### Charlotte-Mecklenburg Planning, Design, & Development

**SUBJECT:** Administrative Approval for Petition No. 2018-144 Portman Holdings

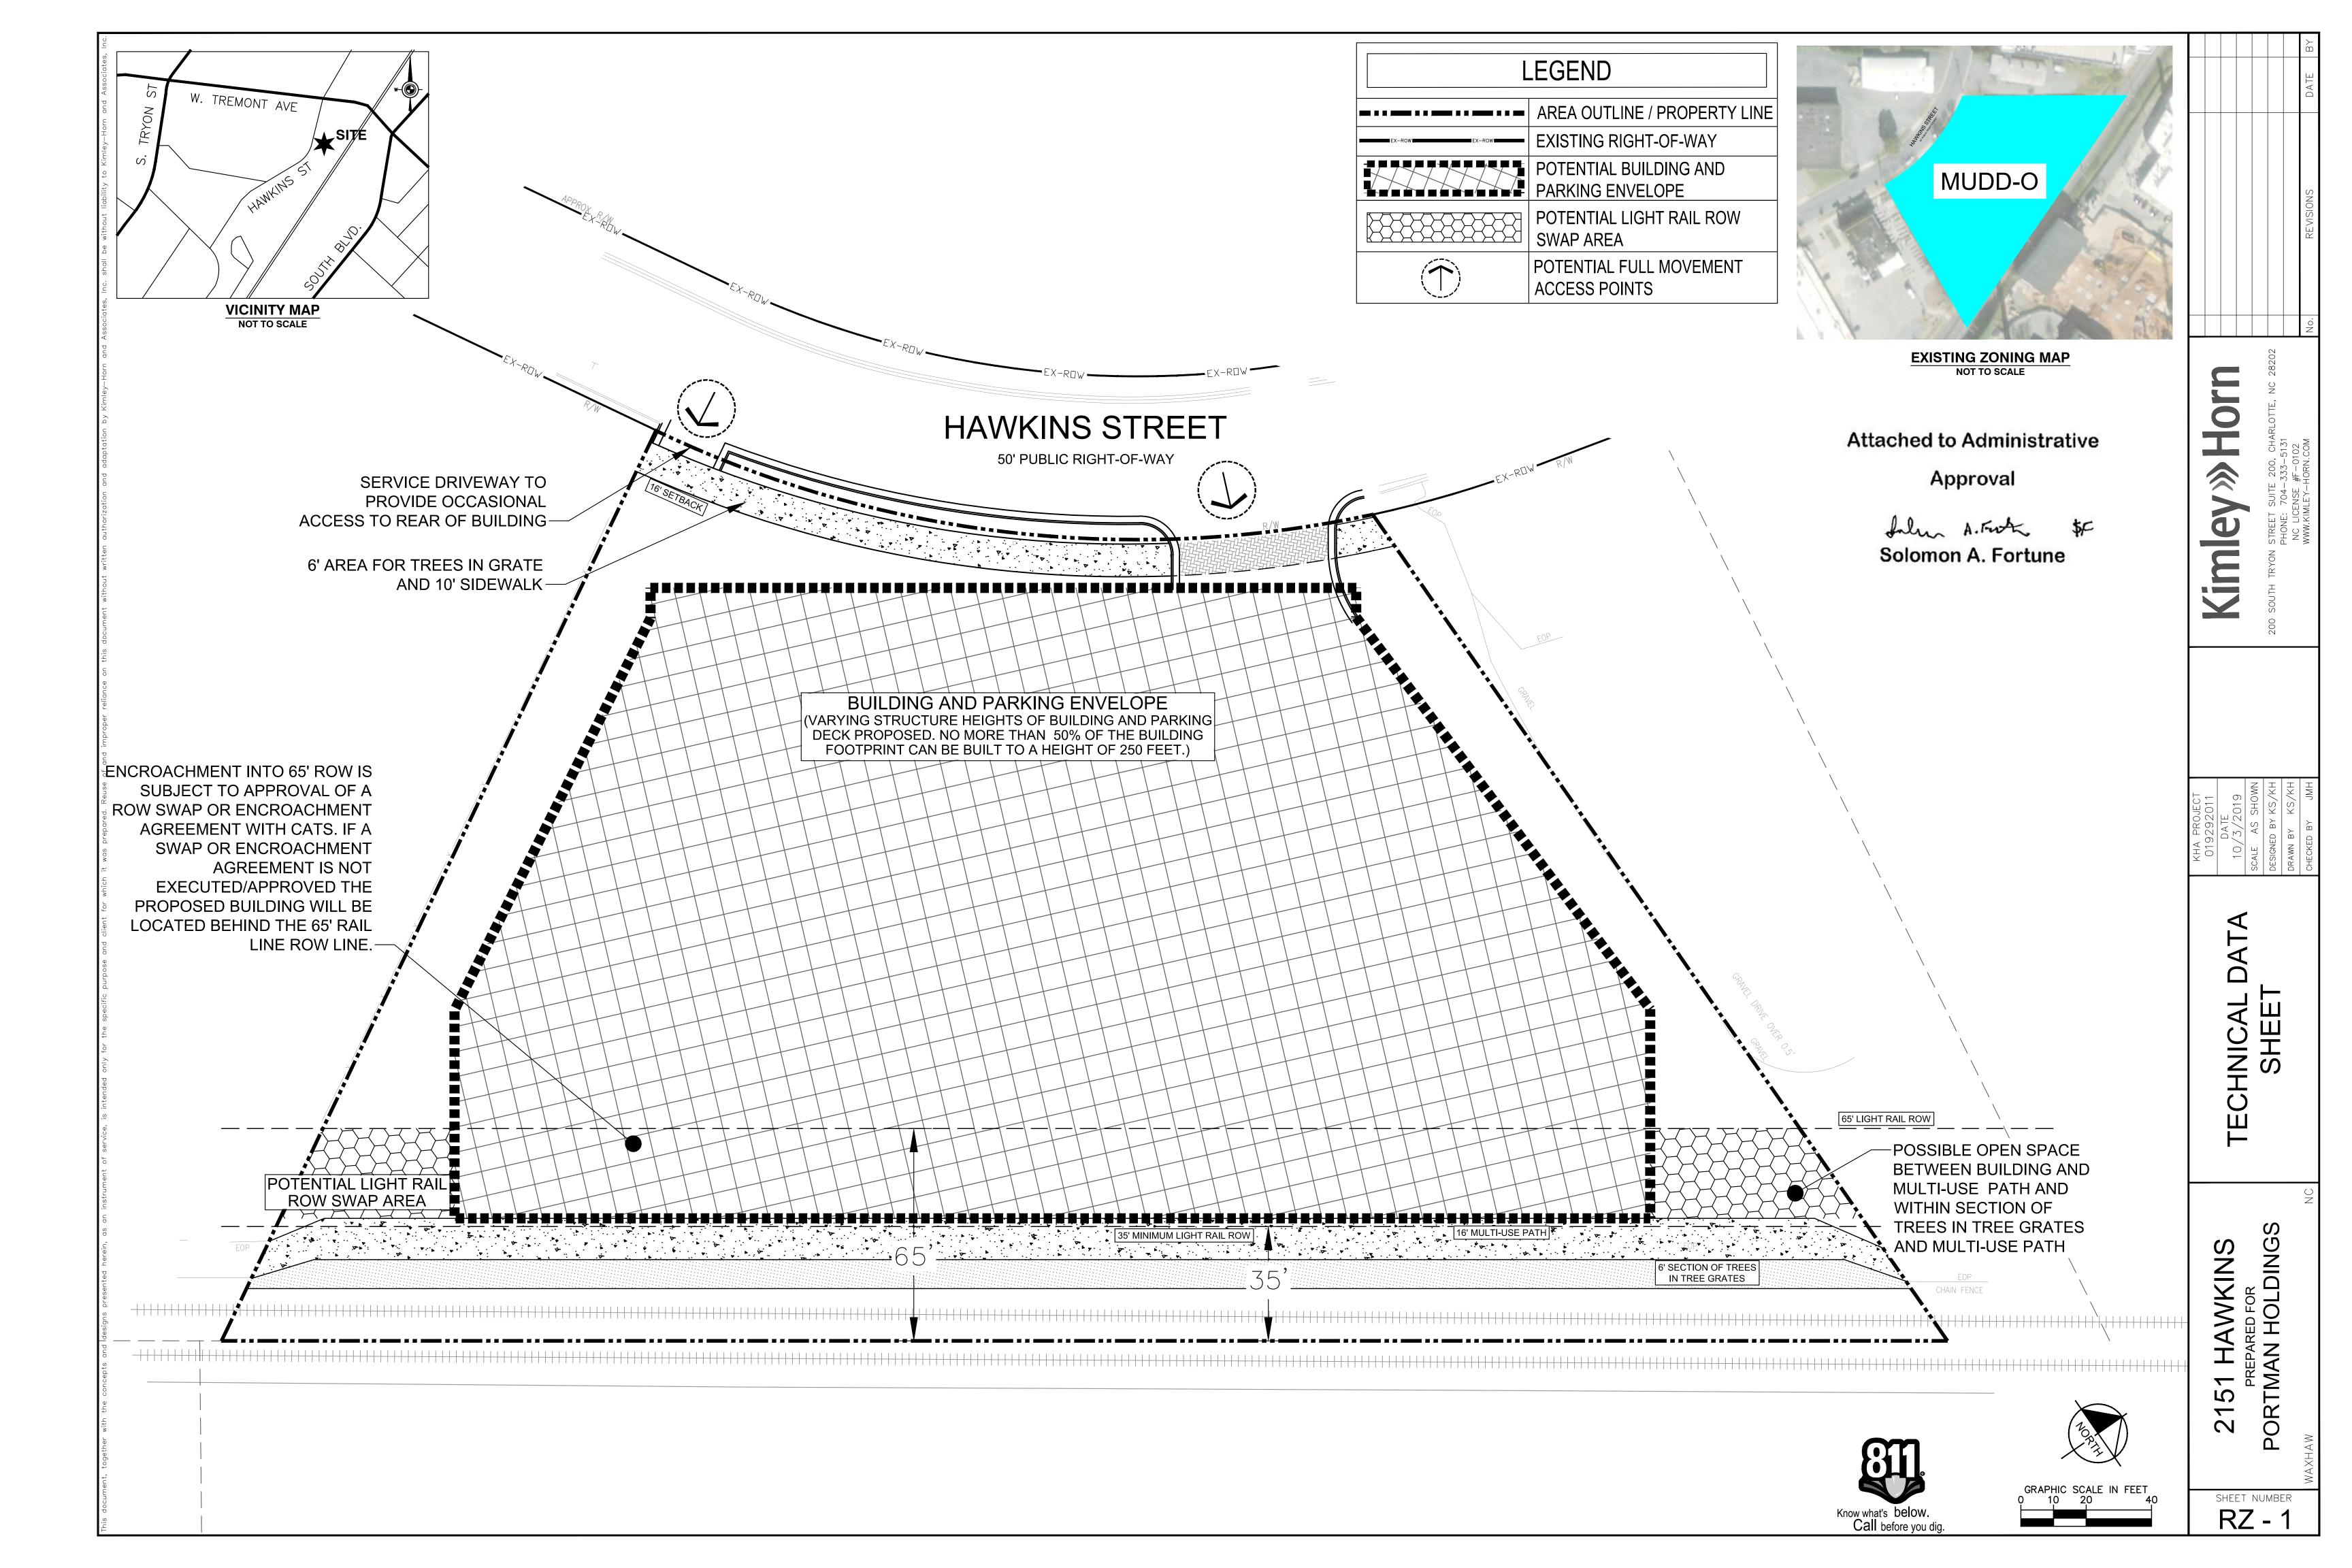
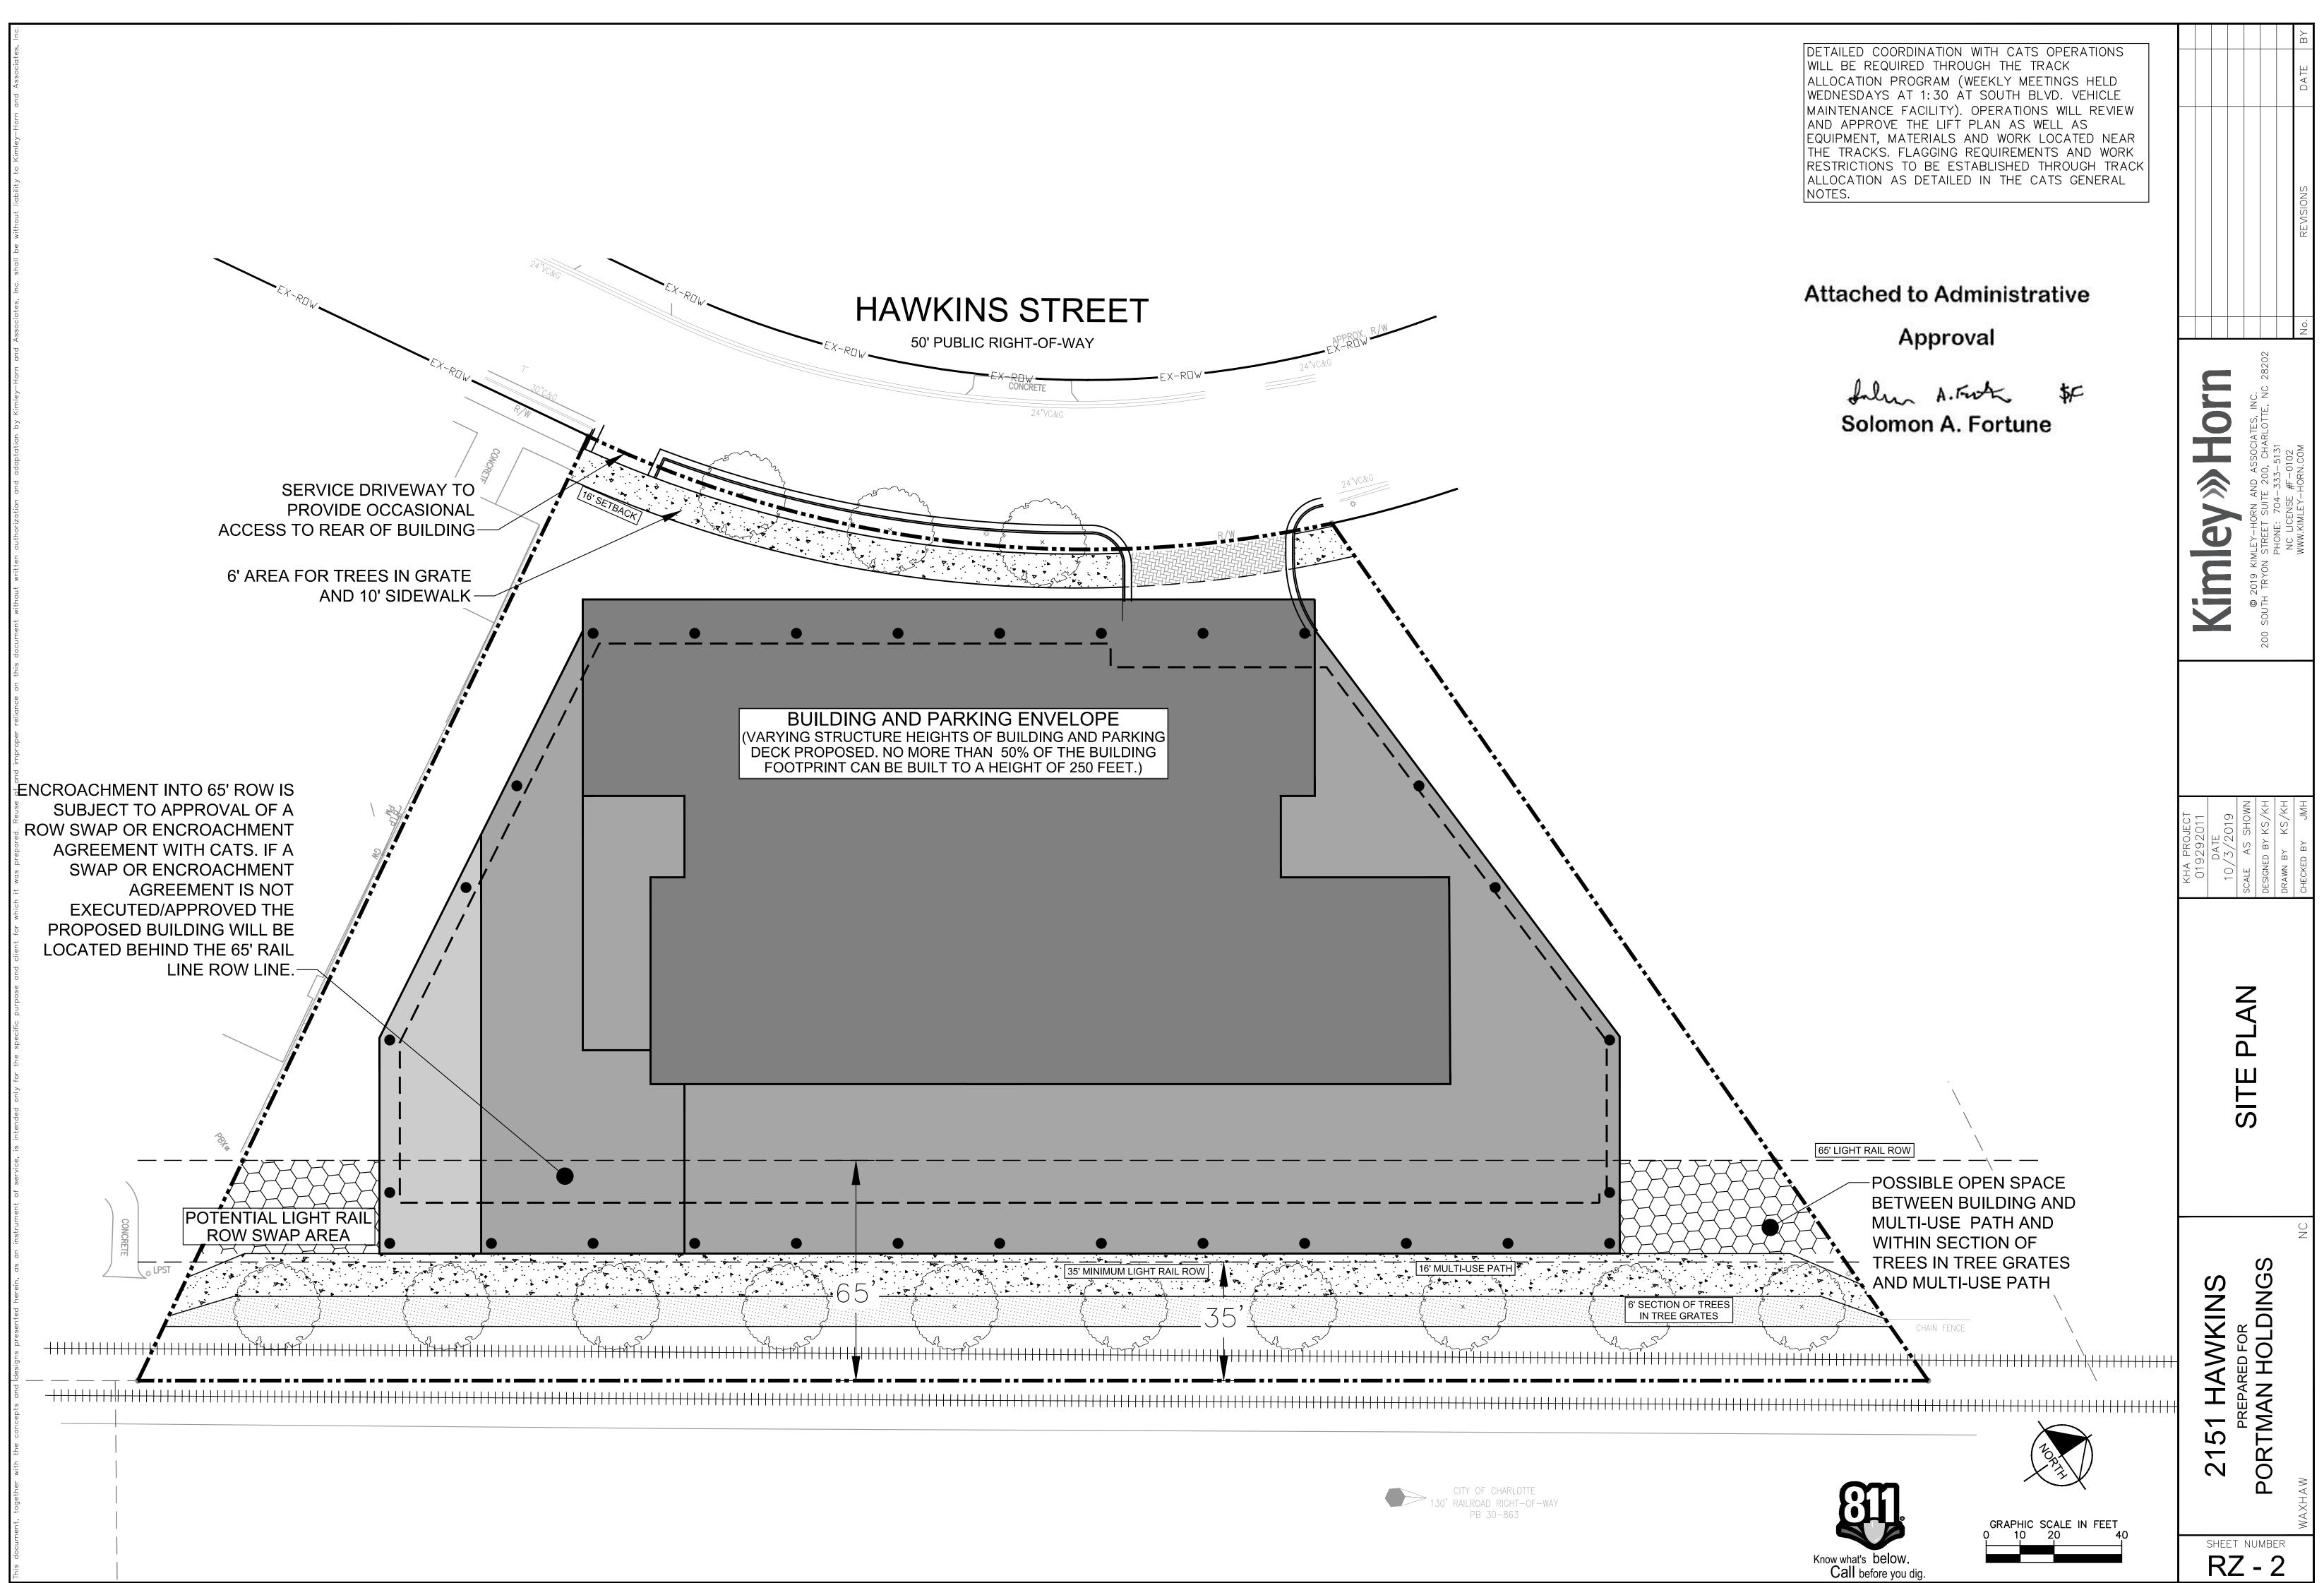
• To allow modification to the building layout on the site.

• The site plan complies with the conditional notes and still meets the intent of the original approval by the City Council.
